**Model:** SR7300

**Subject:** A high frequency noise heard in speakers

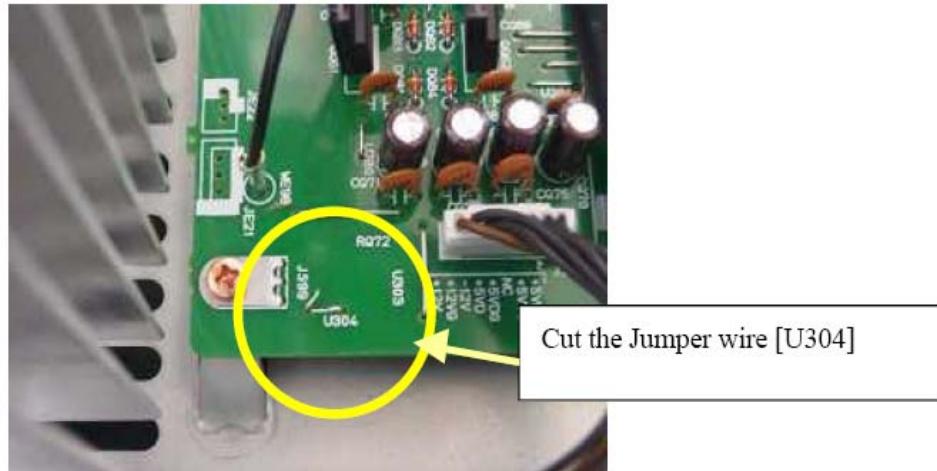
1) Cut the jumper wire [U304] on the PS04 board.

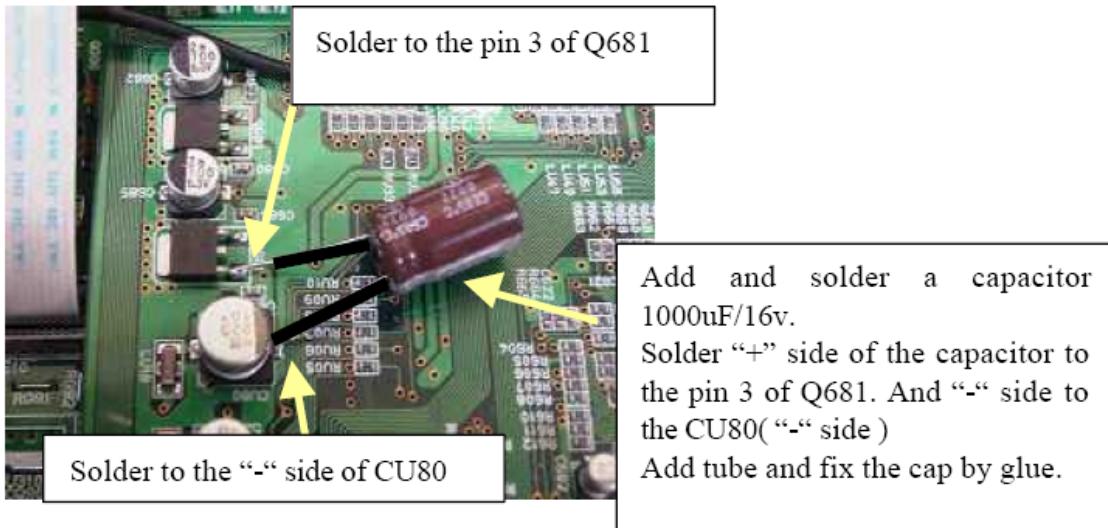
2) Add a 1000uF/10V capacitor between pin 3 of Q681 and the “-“side of CU80 as follows.

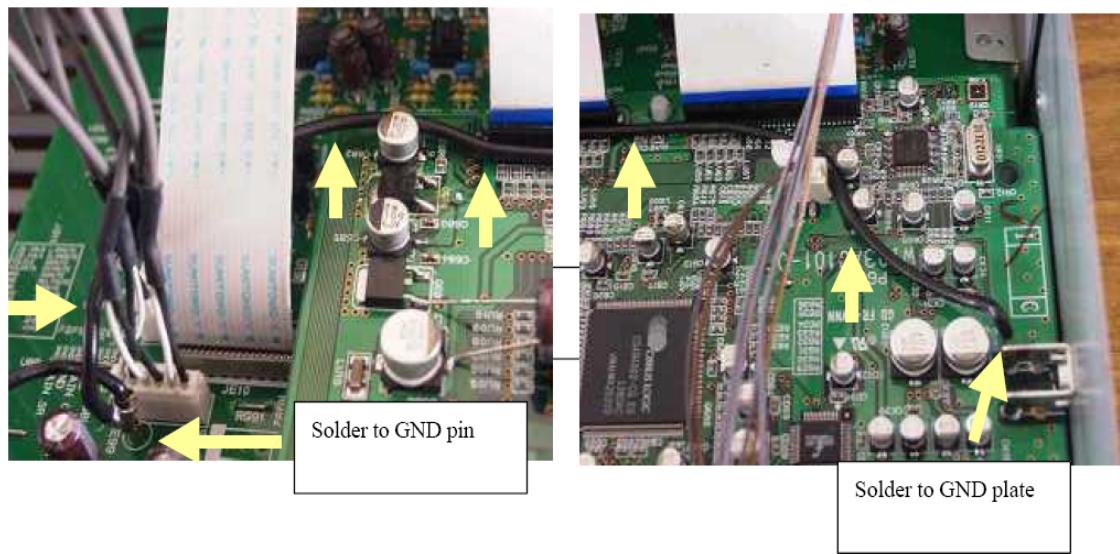
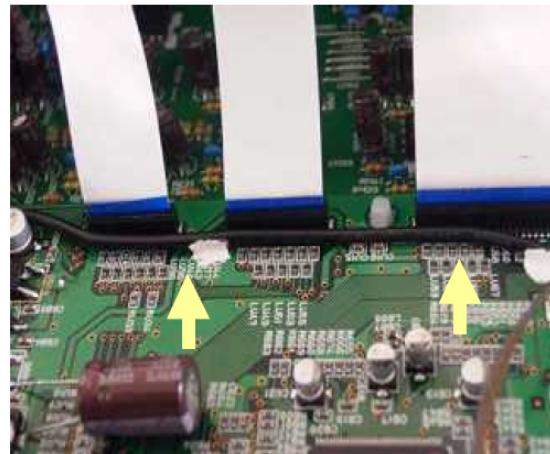
1) Add a wire (Length approx. 23cm: Wire size #18 or #20) as follows. (GND to GND) Note: Wiring must be done as following and fixed with glue (heat-resistant type). See picture below for details.
